# PERMIT

## SEWAGE DISPOSAL SYSTEM

#### HOWARD COUNTY HEALTH DEPARTMENT

REPAIR - PURPOSE - SEPTIC SYSTEM HAS FAILED.

INDICATE NORTH - NAME ADJOINING ROADWAY AS BASE LINE

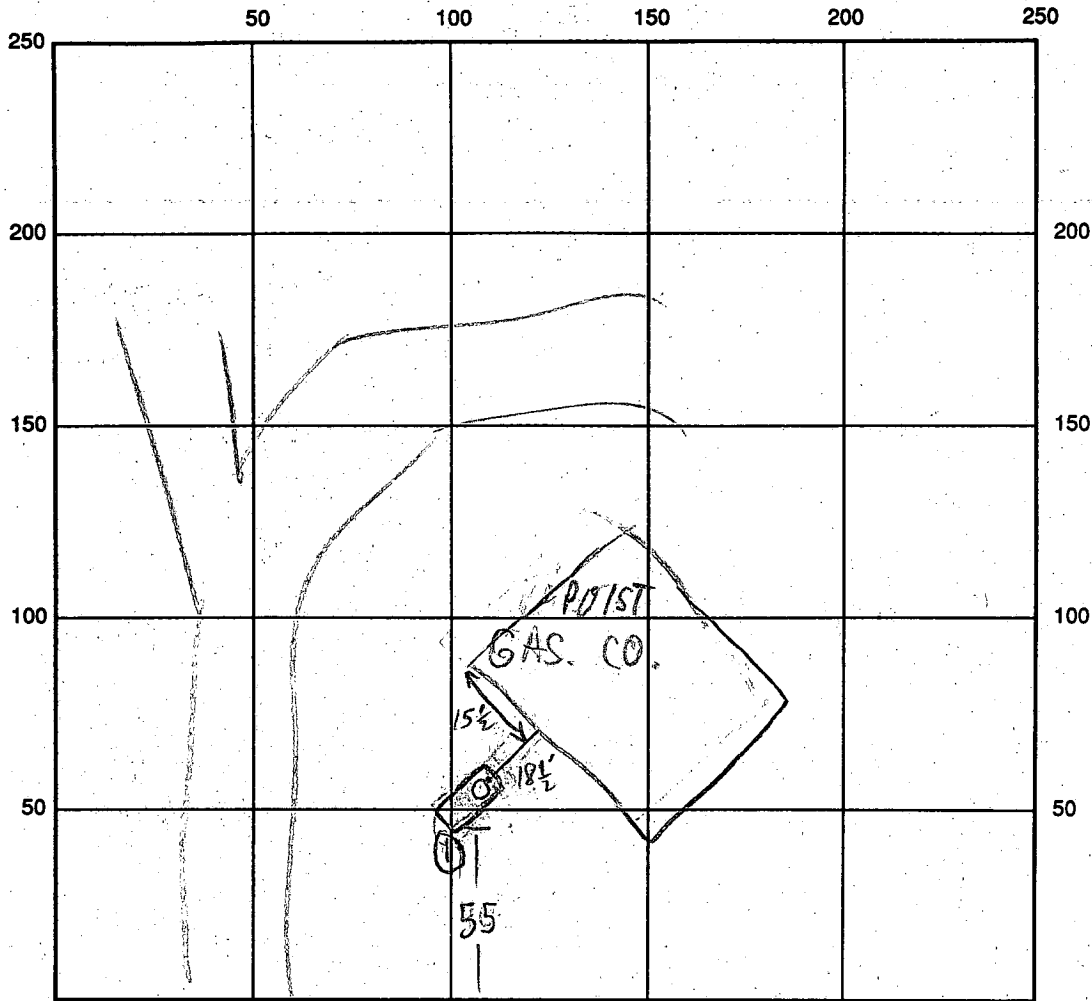
REMARKS: 3/30/94 #1 DUE TO POOR SOILS, HOLDING TANK REQ'D; TOP-SEAM REQUESTED, NOT AVAIL. ⇒ STANDARD TANK W/TAR OK MR

3/30/94 #2 S.T. SET, NOT YET FINISHED MR

3/31/94 OK TO COVER ALL; SMALL EX. TANK TO BE FILLED TOMORROW MR

LOCATION DIAGRAM

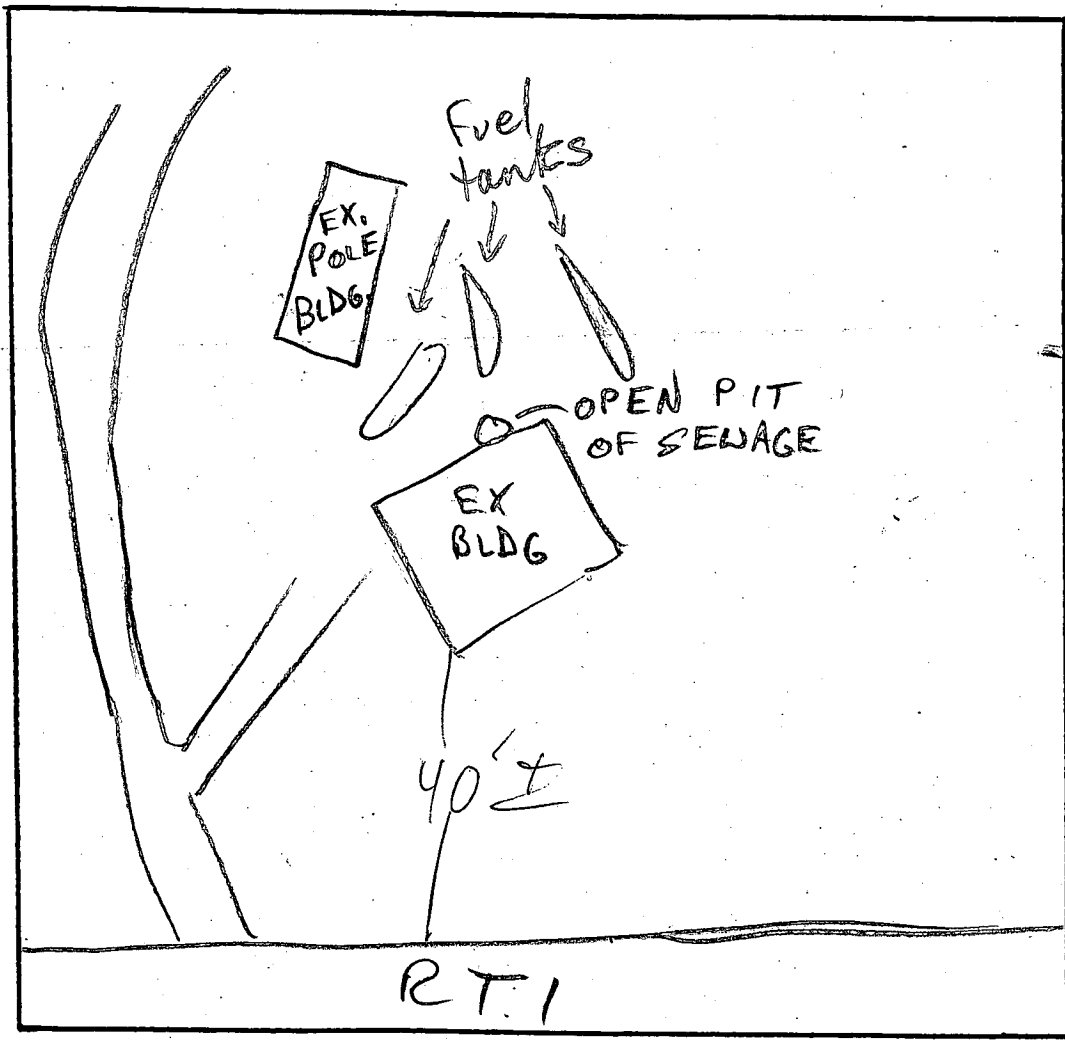
COMMENTS: SEE ~~NO~~ COMPLAINT SHEET ATTACHED
